Vermont Agency of Transportation
RECEIVED
CK'D BY M.E.M. OK'D BY C.W.M.
July 09, 2012
RESUBMIT APPROVED AS NOTED
BY C. CARLSON DATE 07-27-2012

PROJECT: VT RT 9, BRIDGE NO. 11
TOWN OF WOODFORD, VT
OVER WALDOMSAC RIVER

TITLE: CROSS FRAME

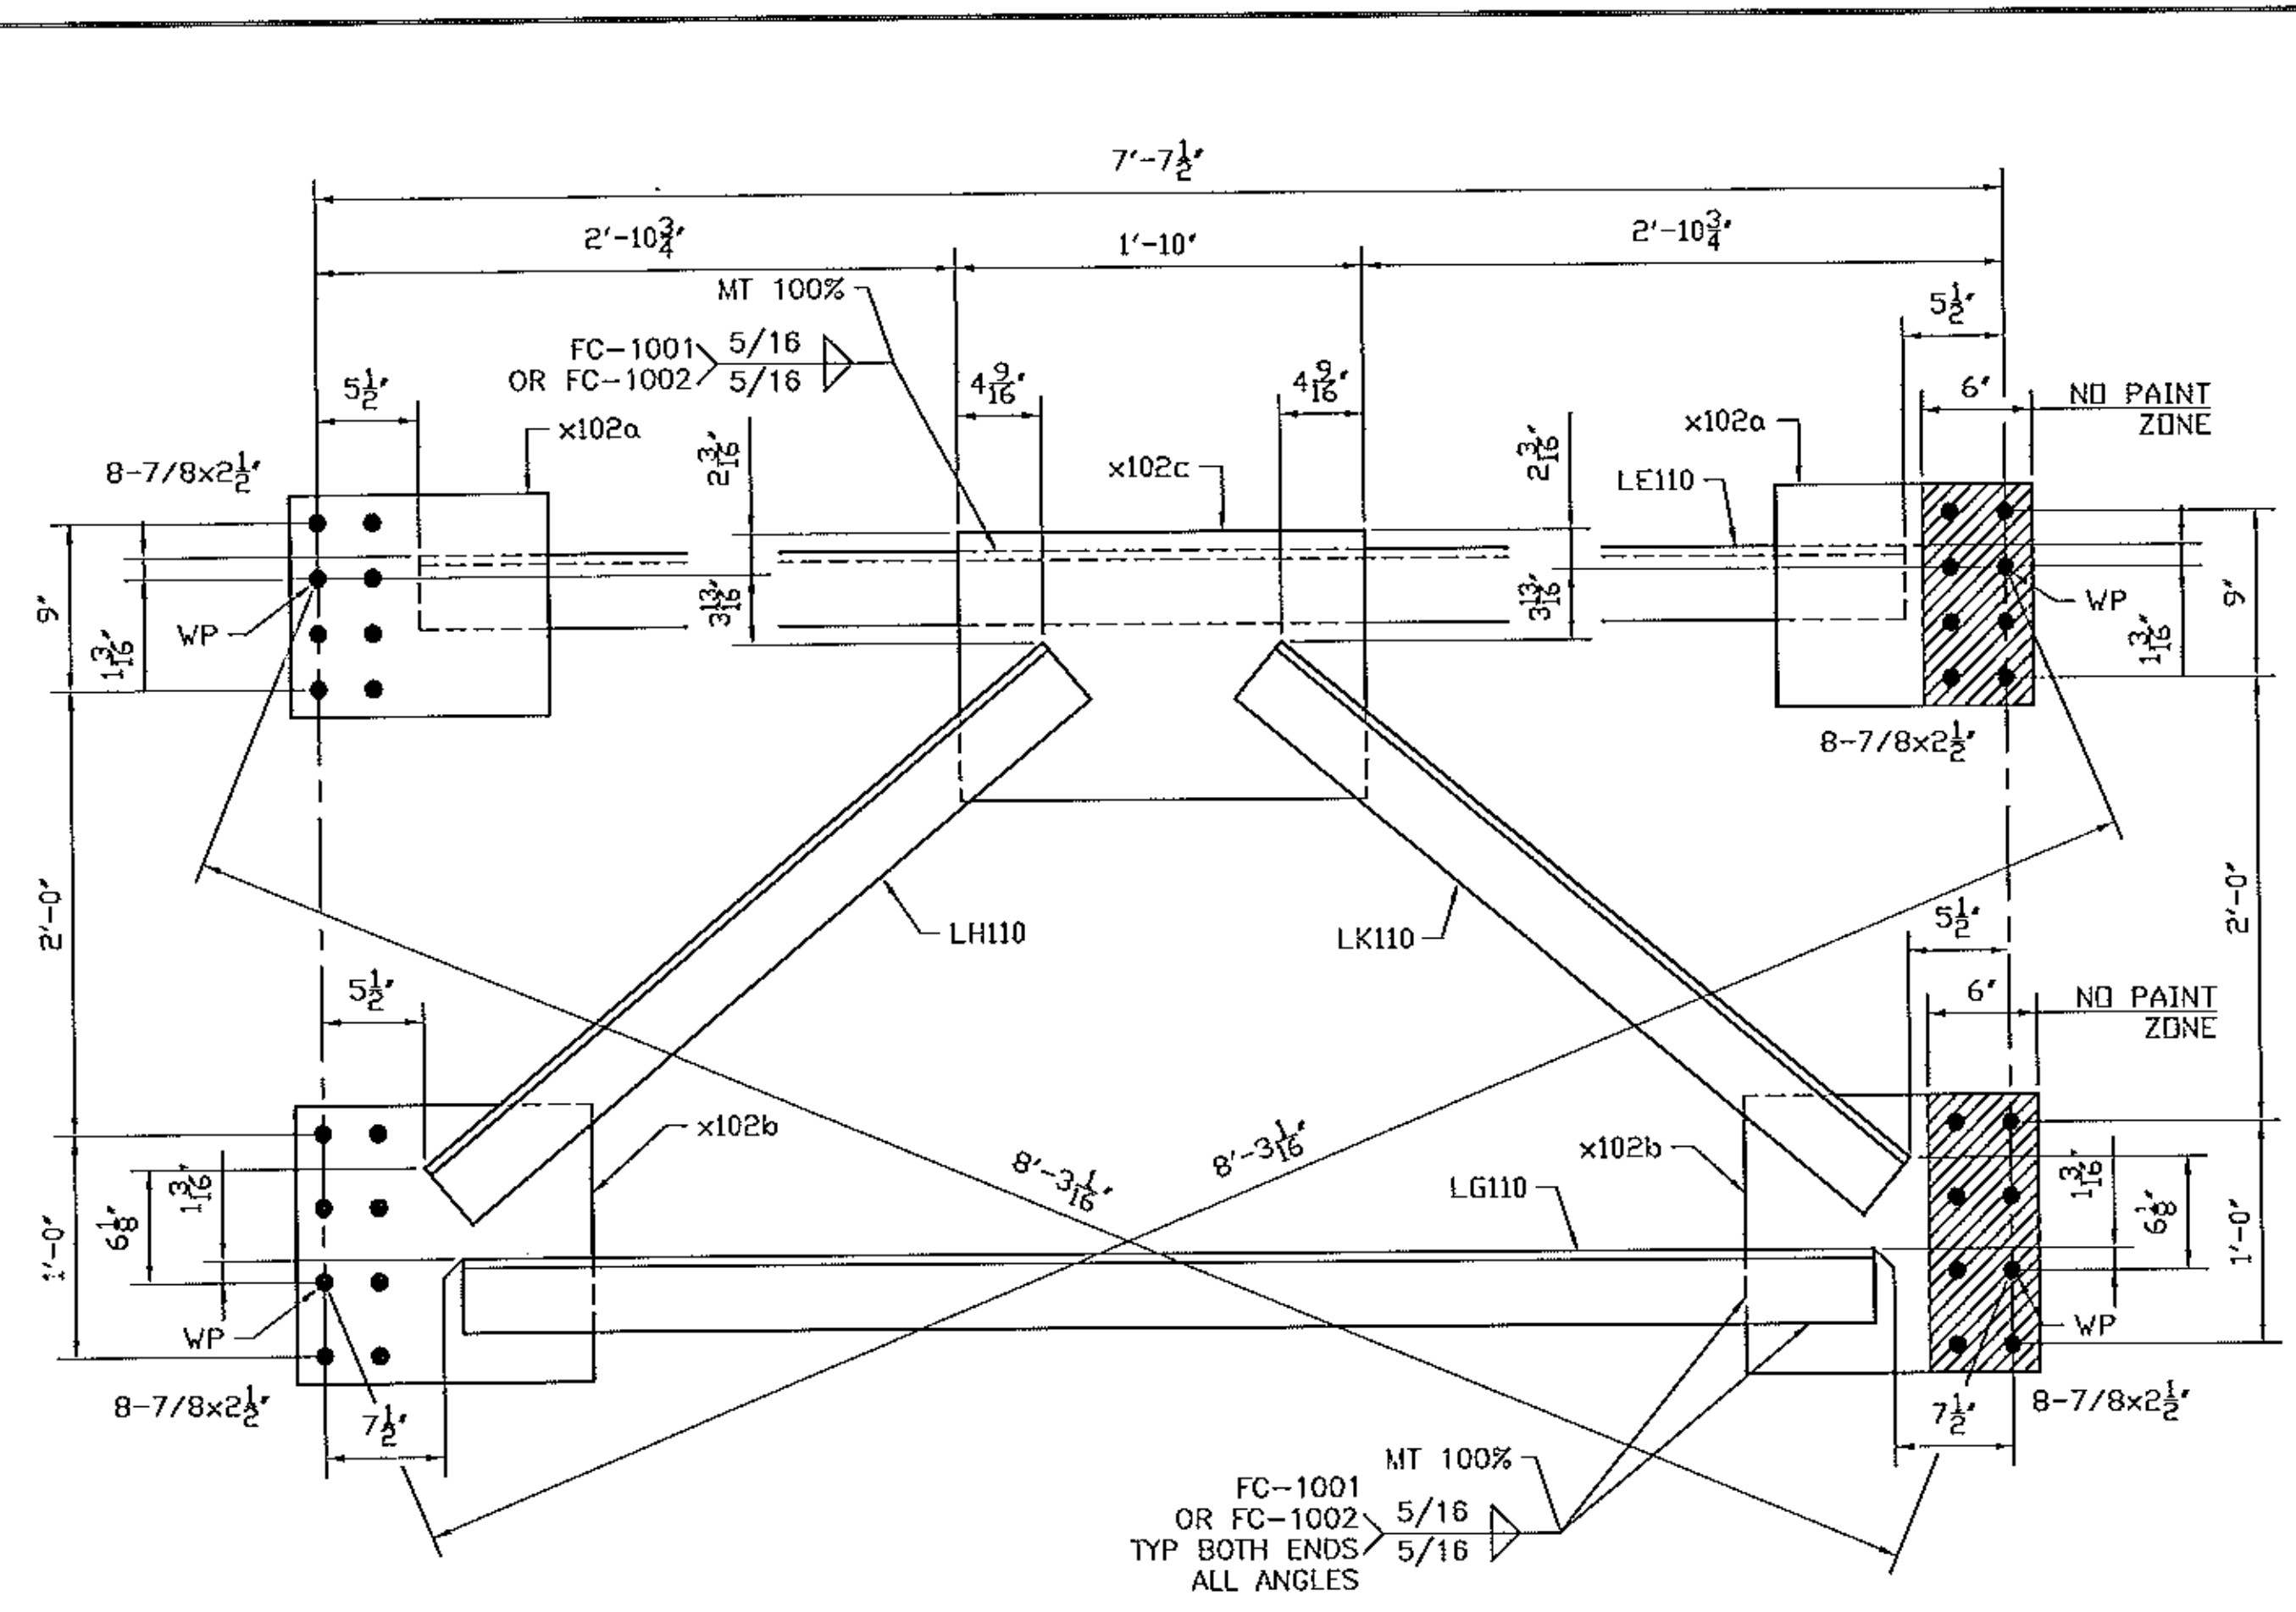
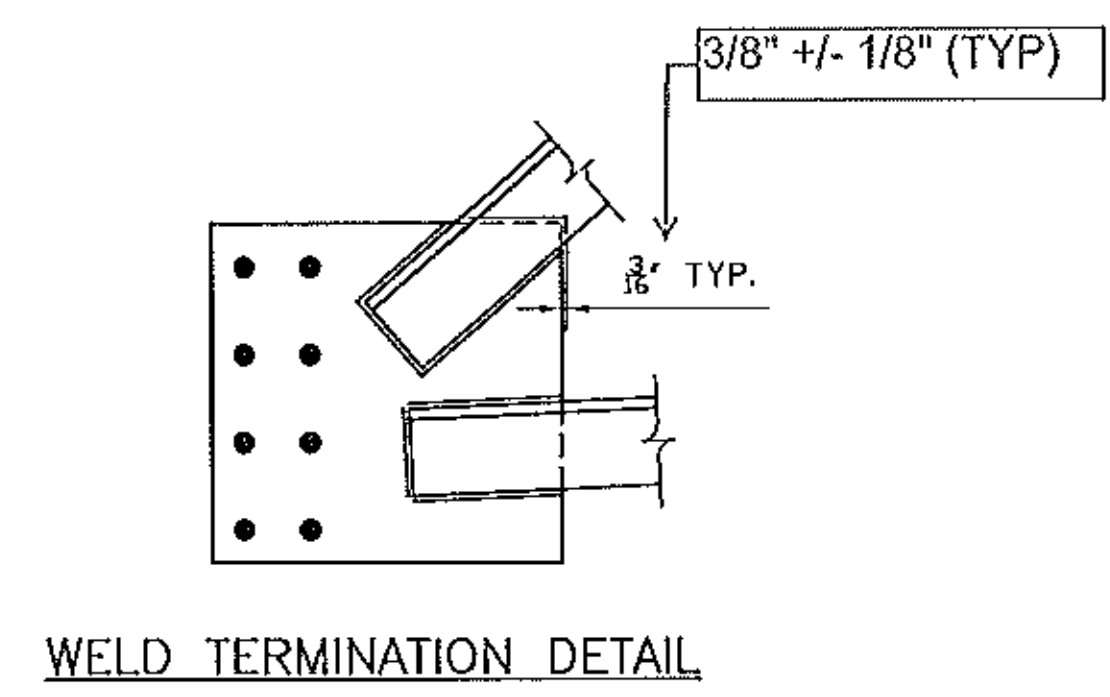
See standard specification 506.24(a)(9), no payment will be made for bolts, nuts, washers, they are considered to be incidental
